Docket Item #11
BAR CASE # 2007-0029

BAR Meeting
March 7, 2007

ISSUE: Addition
APPLICANT: Temple & Marty Moore by Robert Bentley Adams
LOCATION: 207 North Fairfax Street
ZONE: RM/Residential

STAFF RECOMMENDATION: Staff recommends denial of the application.

Figure 1 - Proposed south elevation

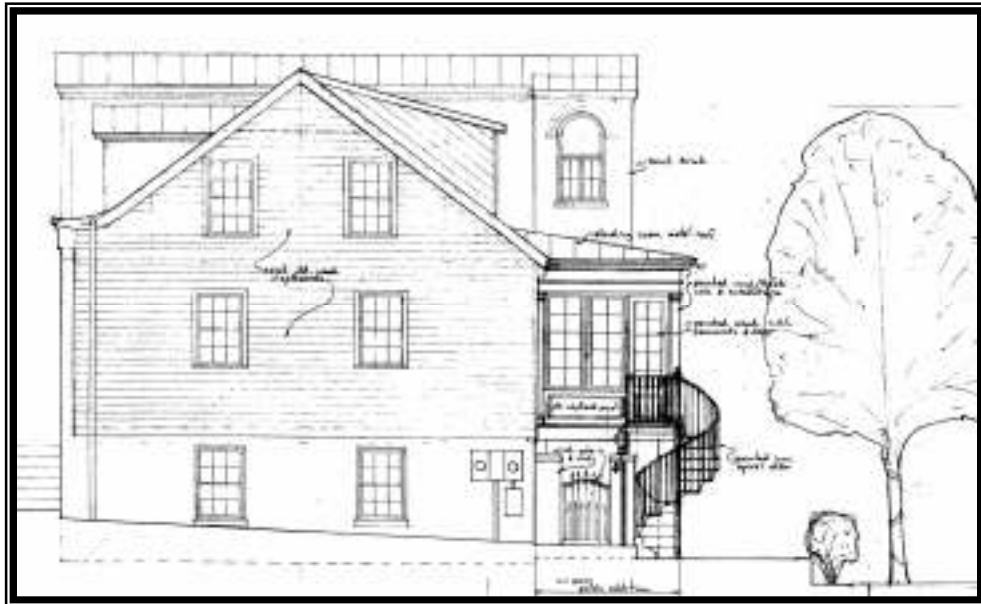
As has been explained to staff, it is the expressed desire of the applicants to “recreate” the frame section that existed at the rear. The “re-creation” is entirely conjectural and will not be same size nor in the same location as the original rear addition. Further, the new addition is an entirely 21st century rendition in all modern vocabulary and synthetic materials

The smallish one story rear addition that previously existed was built well more than one hundred years after the original house was constructed and was extant for only approximately 50 to 70 years, and thus should not be considered an essential element of the house that calls out for replication.

Furthermore the design of the rear addition proposed in this application is nearly identical to a third story addition that was designed by the same architect and approved by the Board for the residential rowhouse at 526 Queen Street in 2002 (BR Case #2002-0167, 9/4/2002). In that case the addition was for a mid-19th century house, while in this case essentially the same design is being proposed for a mid-18th century freestanding house. Staff does not believe that the same design is appropriate for two stylistically dissimilar townhouses.

Staff does not believe that any addition is appropriate that alters the 18th century house to the extent proposed in this application. To repeat from the staff report regarding the proposed demolition: Staff believes that the preservation of houses such as 207 North Fairfax Street was

precisely the reason that the historic district was created more than 60 years ago. Proposing to demolish and capsule a significant portion of an extant 1760s house and attach a modern addition does not respect the significant historic and architectural resources of Alexandria and the historic district. Staff cannot recommend approval of a new rear addition to this structure.

The proposed renovation seems to alter the character of the building too drastically, in particular the spiral metal staircase and expanse of windows. The exterior metal staircase is specifically discouraged for a building of this date in the BAR guidelines. A more compatible and less transforming design should be considered.

Staff recommends denial of the application.
